SIMON Floor Plan Comments:

DATE:	08/20/2018
DRAWN BY:	STAFF
PROJECT NO.:	18125
FILE NAME:	18125 Morphie - The Florida Mall.dwg

1 FLOOR PLAN
A100 SCALE: 1/4" = 1'-0"

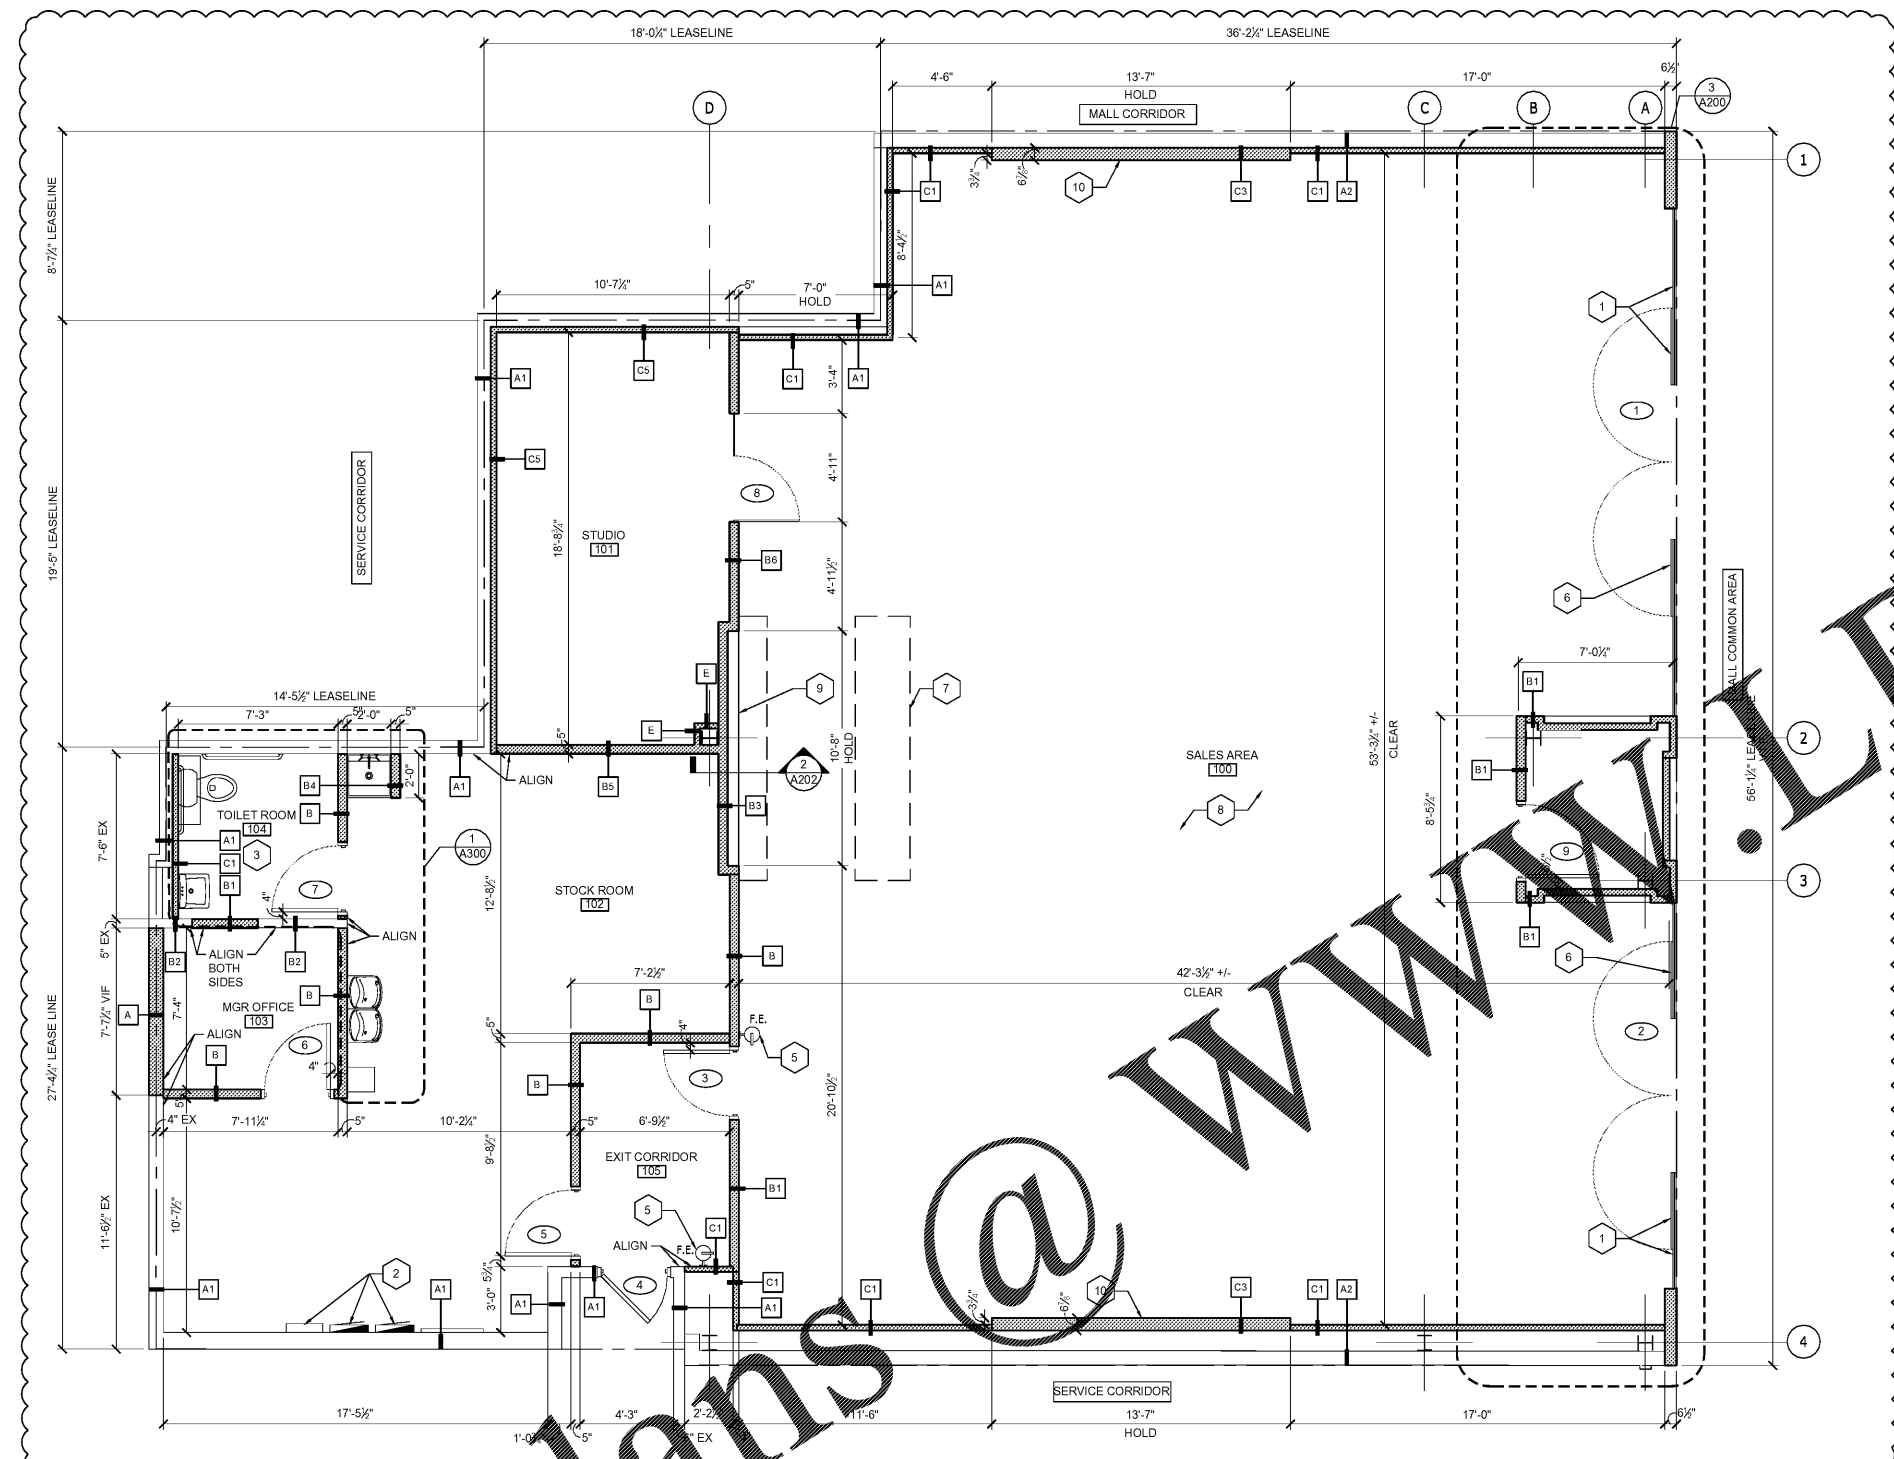
*Tenant is responsible to field verify all existing conditions and dimensions in the space. Failure to properly field verify existing conditions does not relieve the Tenant of any expenses or responsibilities resulting from that failure.

*Nothing is permitted to be attached to, suspended from, or penetrate Landlord's structure, floor deck, or roof deck. You may attach, non-destructively, to or suspend from the top chord of the joist or the structural steel which exists above the lowest space. When attaching to Landlord's structure, do NOT drill, weld, screw, or staple into structure. Alternative methods of attachment OR, if, referring to structural details, base building structure, Tenant shall provide, design and sealed structural drawings, by a structural engineer, legally prove registration as indicated in particular requirements, for all structural modifications, for Landlord records.

*Structural reinforcing details shall be provided by a registered structural engineer to Tenant's satisfaction for all most of or suspension, service channels, duct penetrations, etc.

*Any electrical equipment, components, and/or service leading other than that is existing in the space must remain visible and accessible to the Landlord. Tenant shall install access panels as required for electrical access. Access panels shall be labeled in permanent, legible system, coordinate with Mall standards.

*A stockroom may not be visible from the sales area. (s) leading to the stockrooms must have an automatic closure.

*All rear entries must have a doorbell for deliveries.

*All concrete patching must be level with the existing concrete floor.

*Tenant is required to install a waterproof membrane in all wet areas (Restrooms, Kitchens, food services, etc...) of the space. Tenant shall use a 30 mil polyethylene cleavage membrane (equal to Koblement 18) installed per manufacturer's recommendations and ANSI A138. Membrane must be extended up the wall a minimum of 6" or equal to the height of the floor base.
